1.0 APPLICATION SUMMARY

Request: Minor Modification to PD 14-0815

Proposed PRS 25-1200

2.5 Proposed Site Plan

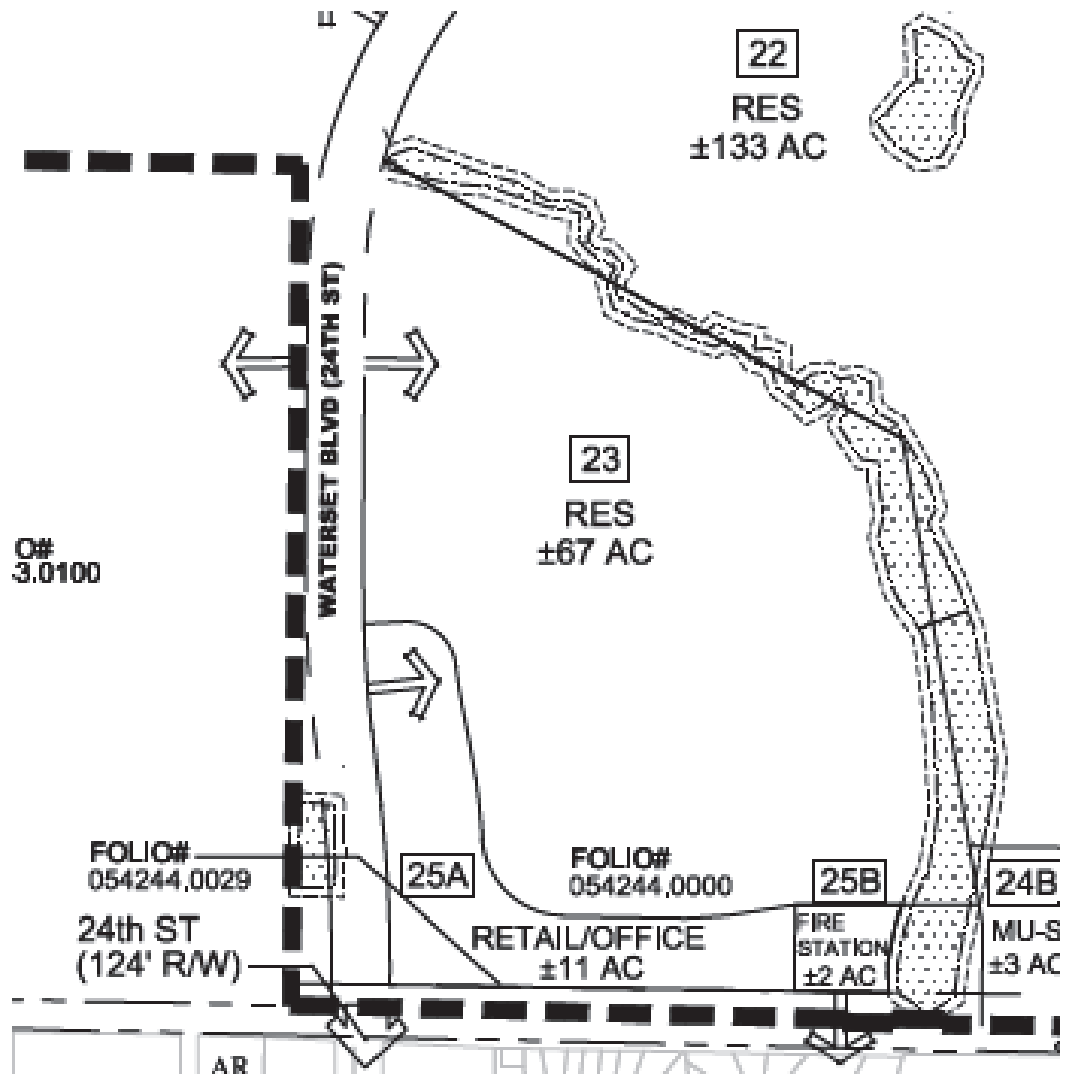
Tract 25A: Reconfigure the frontage along 19th Avenue and Waterset Boulevard to better support commercial and retail uses. This change results in a decrease of two-and-a-half acres.

Tract 25B: Designate a two-and-a-half-acre portion of Tract 25 for a community fire station, fulfilling the requirements of Condition 21 of the zoning conditions.

Tract 23: Adjust the tract boundary for residential use without changing the total acreage.

8.3 Proposed Site Plan (Full): Page 1 of 2

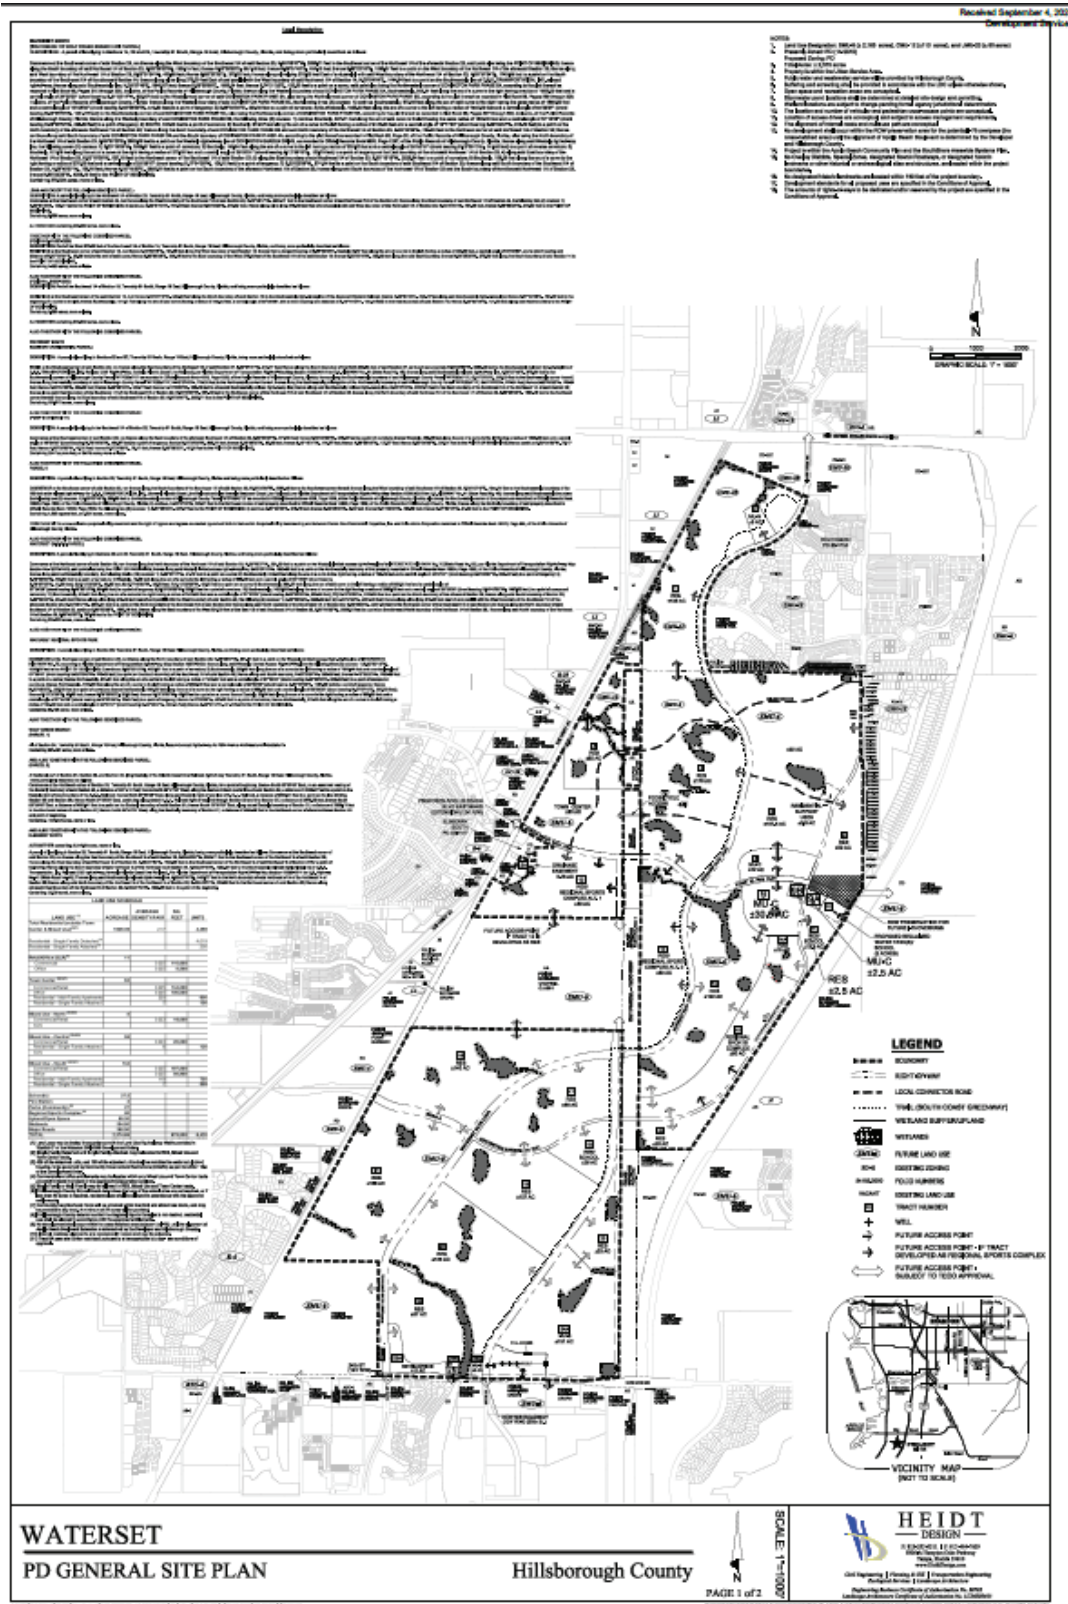
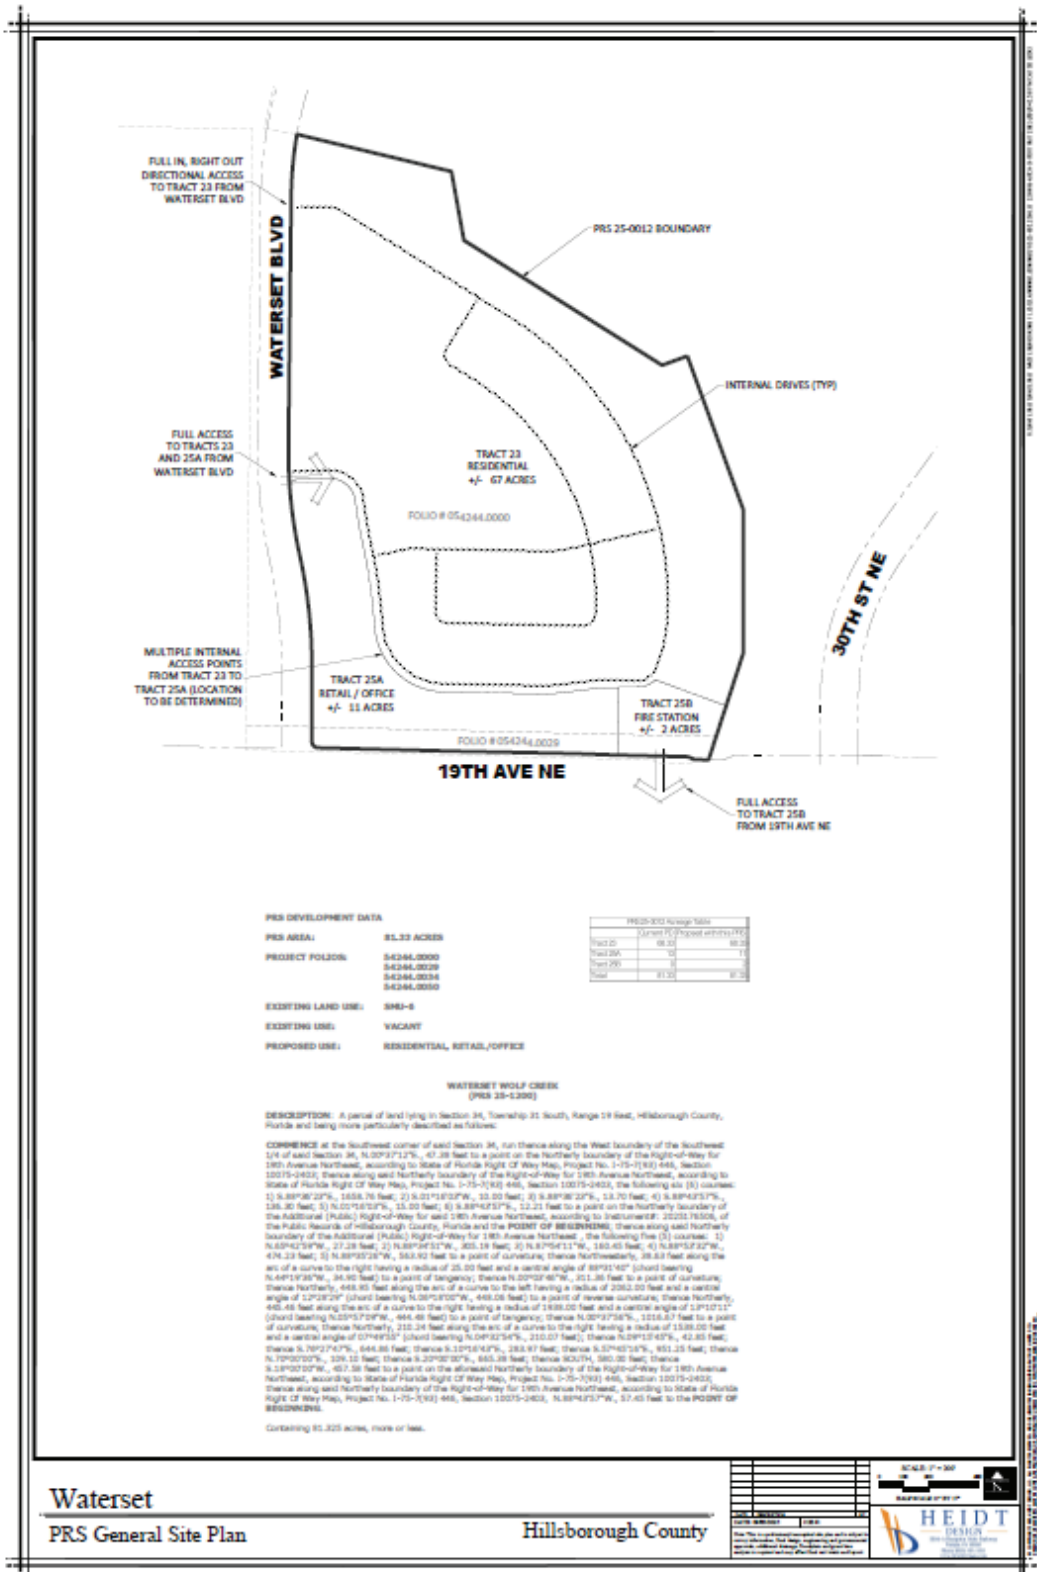
- Correct the label reading "PRS 25-0012 Boundary" with a label instead reading "PRS 1200 Boundary".

- Prior to PD Site Plan Certification, the developer shall revise the PD site plan to:
 - Correct the label reading “PRS 25-0012 Boundary” with a label instead reading “PRS 1200 Boundary”.
